INTRODUCTION

This report contains the results of a Stage 3 Safety Audit carried out on the above scheme. The Audit was carried out at the request of Mott MacDonald, Cambridge on behalf of Hertfordshire County Council.

7.0 Problem Location Plan

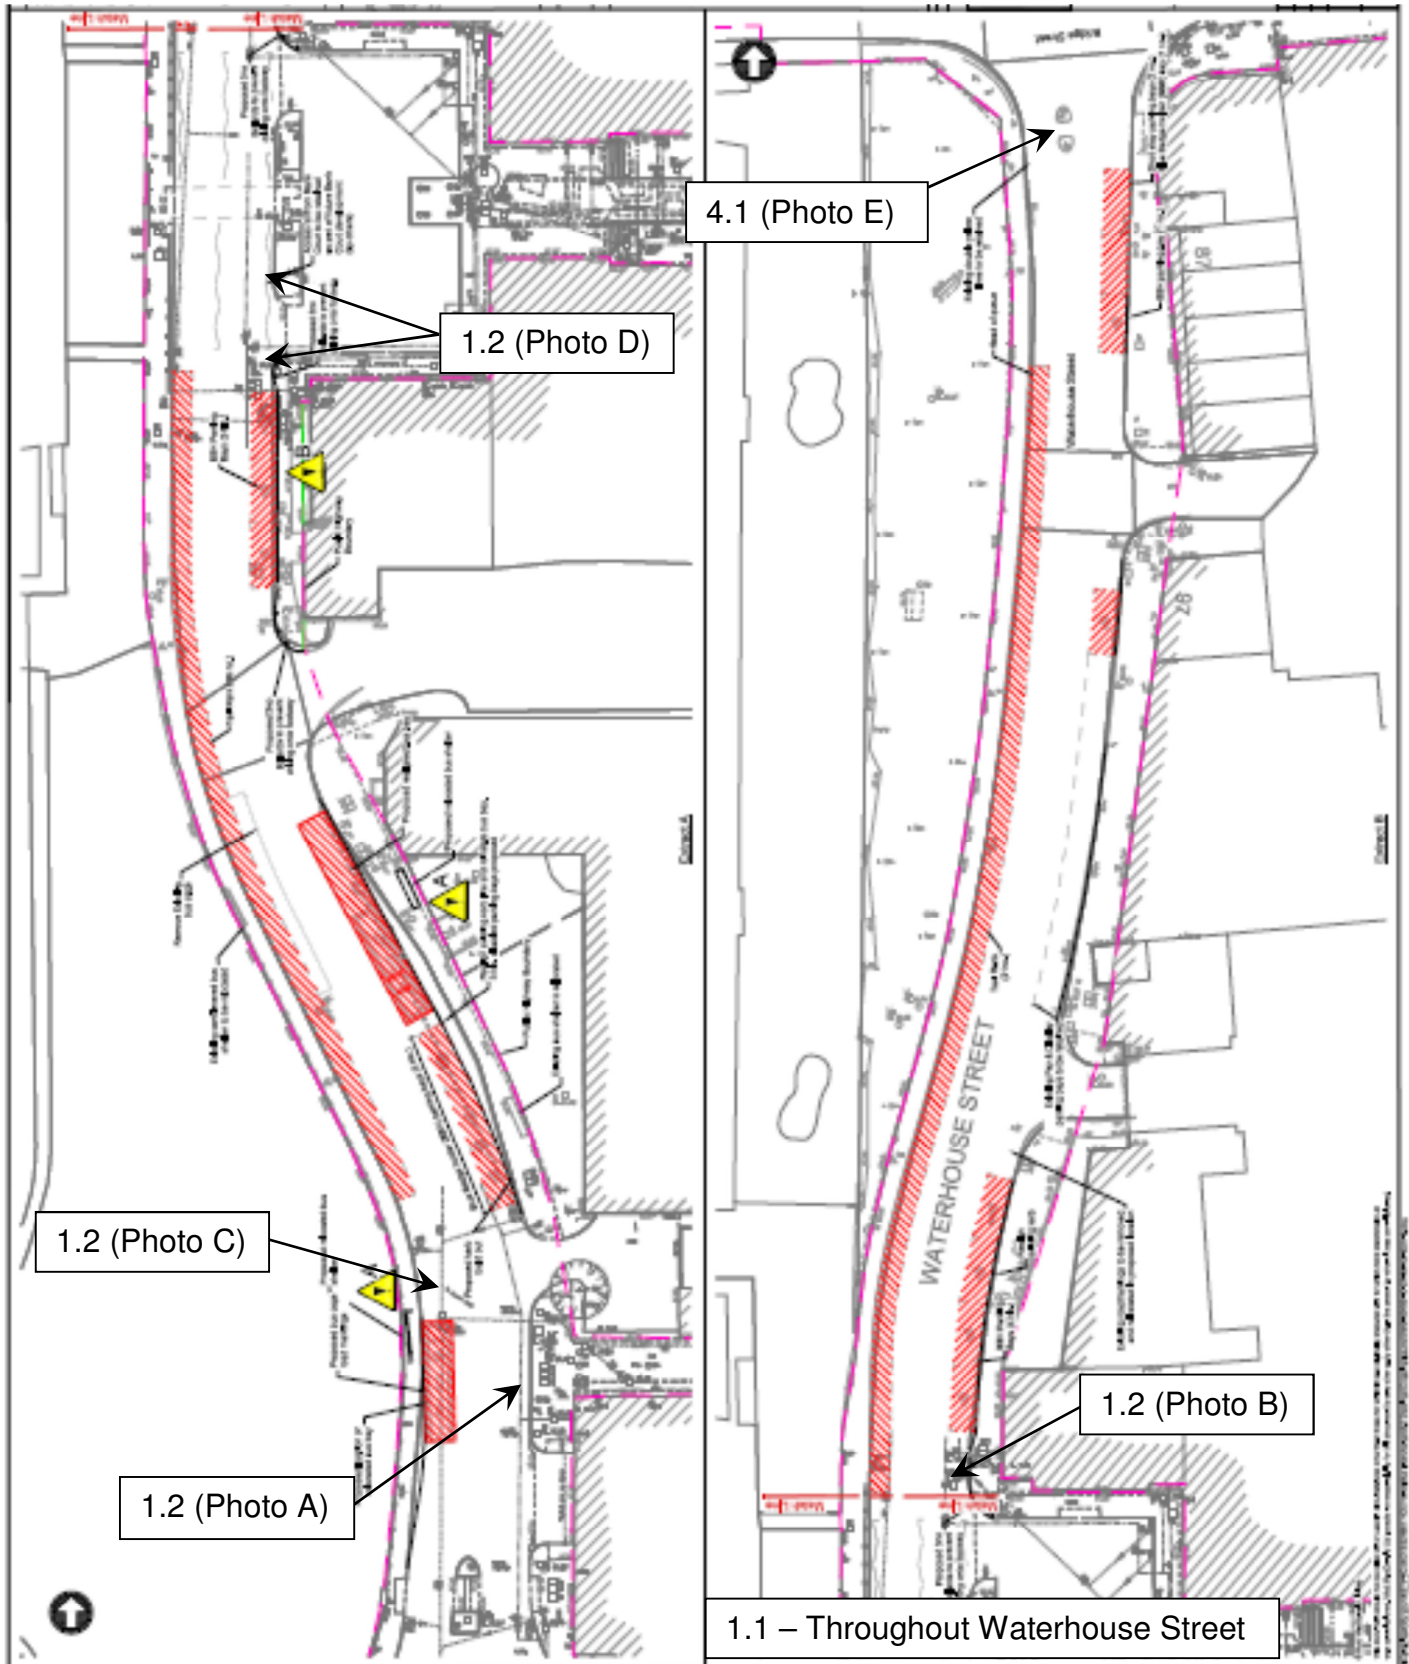
Problem – Speed Limit inappropriate to pedestrian/cyclist environment

The proposals to relocate the taxi rank and reduce on street parking have decreased through traffic and potentially increased pedestrian crossing movements of Waterhouse Street. A reduction in superfluous road markings has contributed to a less traffic dominated environment and the existing 30mph speed limit is now inappropriate. The Designer's Response to the Stage 1/2 Safety Audit stated that following adoption of DfT Guidance for Setting Local Speed Limits by Hertfordshire CC an application would be made for a 20mph speed limit on Waterhouse Street. This has not yet been implemented.

Problem – Location of Green Badge Parking raises risk of conflict

The Waterhouse Street Scheme has seen the replacement of several disabled parking bays with taxi ranks. Although some disabled bays are retained, there is a net loss and during the site visit demand far exceeded capacity. As a consequence the majority of the short sections of ‘No Waiting At Any Time’ restrictions were used by Blue Badge Holders. Several of these are at locations which hinder access or raise the possibility of conflict, such as adjacent to pedestrian or vehicular accesses, or immediately next to bus stops. Conversely, long lengths of taxi rank were unoccupied. Illegal and potentially unsafe parking was also observed by non-Blue Badge holders on pedestrian crossing zig zags and at pedestrian accesses.

Problem – Inadequate crossing facilities increase risk of pedestrian/vehicle conflict

The existing pedestrian refuge island at the north end of the Waterhouse Street scheme is narrow, at approximately 1.5m in width. This is a key pedestrian desire line for access to The Marlowes from car parks and the head of the taxi rank. Site observations indicate that the existing refuge is too small to accommodate groups of pedestrians and there is an increased risk of pedestrians being struck by passing traffic. The Designer's response to the Stage 1/2 Safety Audit stated that analysis would be undertaken to establish whether a larger island could be accommodated, although this has not been confirmed.

To promote appropriate driver behaviour and improve the street environment for all users, it is recommended that a 20mph speed limit is implemented on Waterhouse Street.

It is understood that alternative disabled parking provision is located within the nearby car parks. It is recommended that dialogue takes place with local disabled user groups to highlight this and encourage alternative parking arrangements. It is also recommended that enhanced parking enforcement is undertaken to deter any illegal and unsafe parking.

During the site visit, the long lengths of empty taxi rank suggested an appropriate balance of parking provision may not have been struck on Waterhouse Street. It is accepted that at other times, such as Saturdays and around Christmas, that demand for taxis is likely to be higher. Nevertheless, it would be prudent to review usage of the various parking bays and restrictions after 6 months and consider re-allocation as required.

Provide a wider 1.8m pedestrian refuge and delineated contrasting surface, similar to that on the Bridge Street arm of the mini roundabout to highlight the crossing. Two rows of buff coloured tactile paving should be provided at the crossing point to aid partially sighted users.
